**Minnesota Air National Guard Base
148th Fighter Wing
Duluth International Airport
Duluth, Minnesota**

**Installation Restoration Program
Final Feasibility Study Addendum**

November 1995

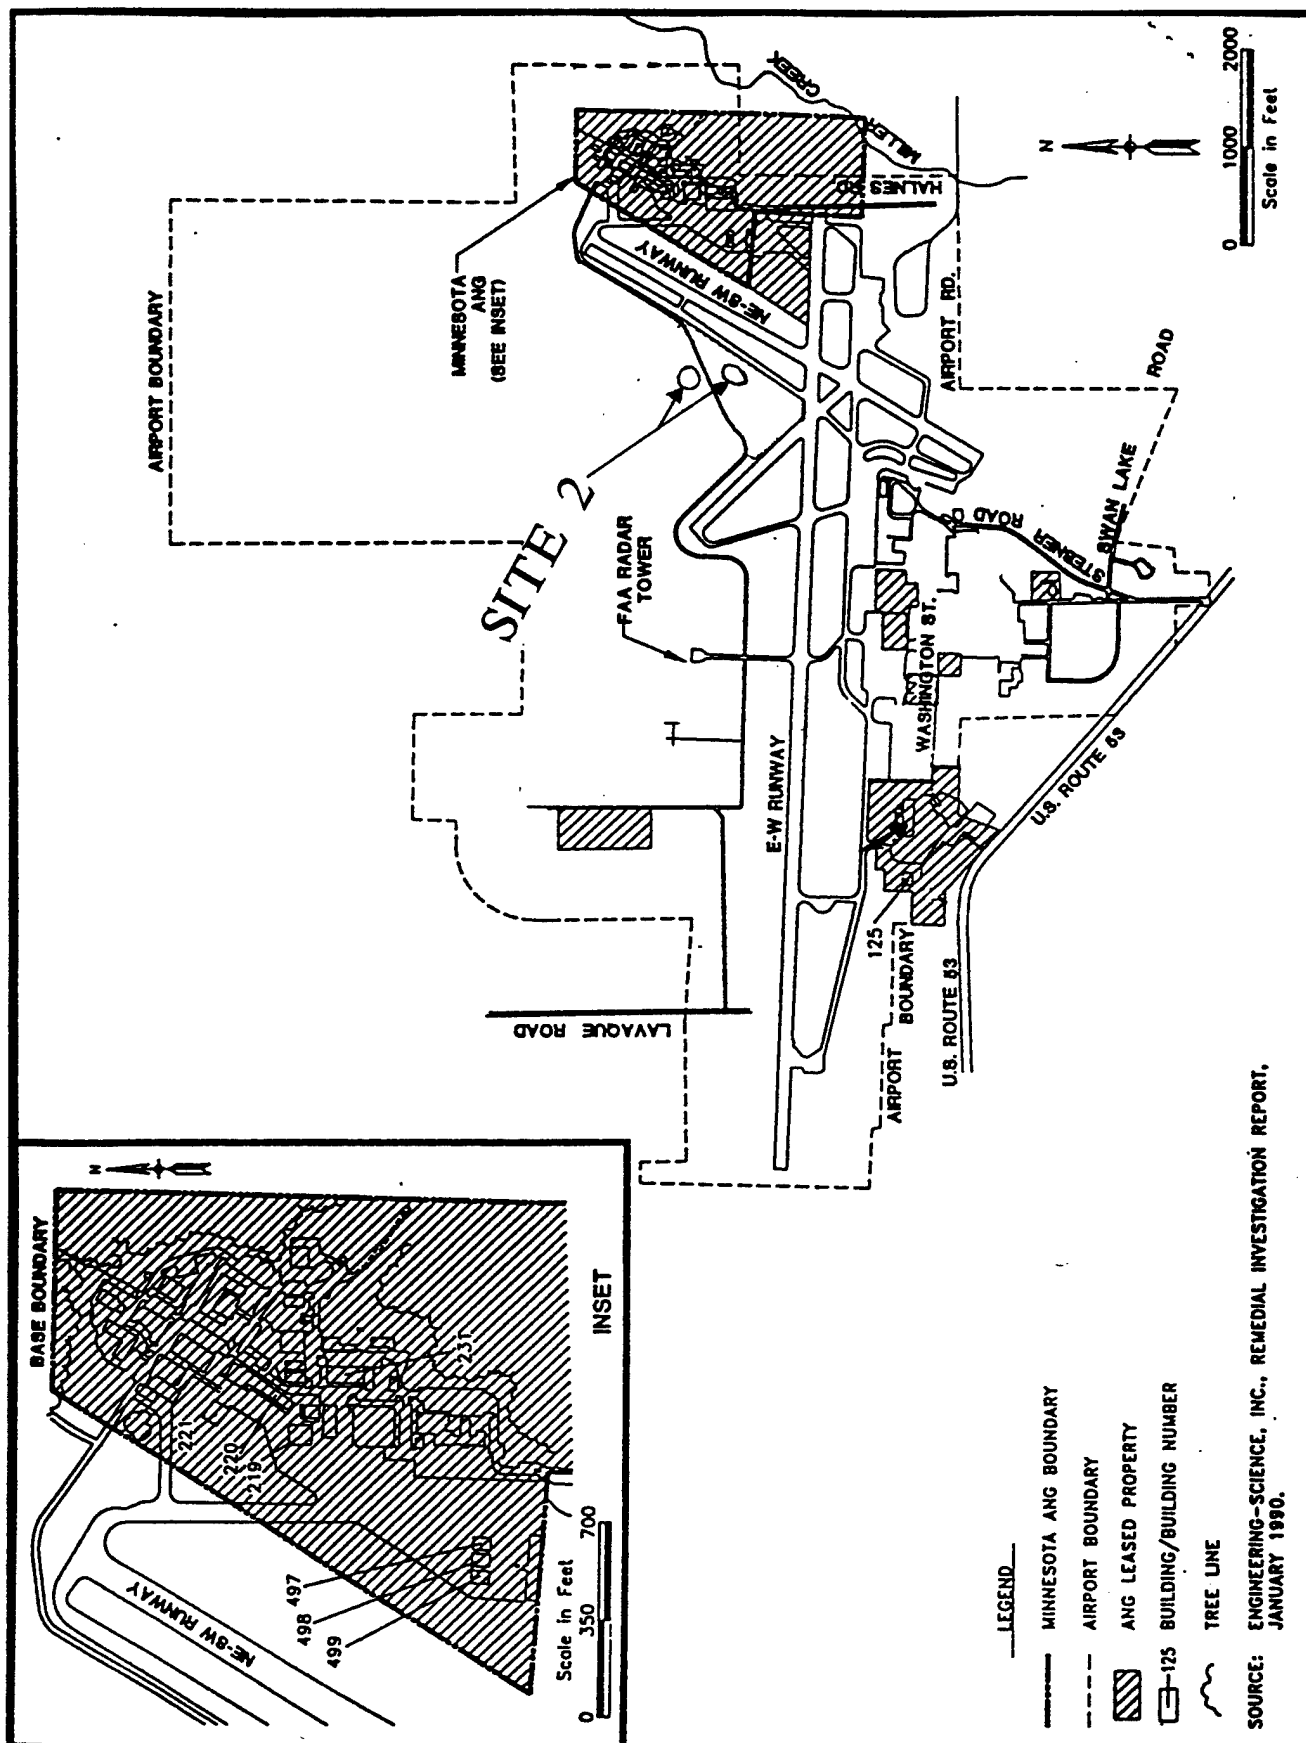
Section 1, Introduction, pg. 1-1, figure 1.1

Why is Site 8 the only site shown on this vicinity map? It would be more appropriate to either show no site locations or show all four sites of concern (but only after reference in the text).
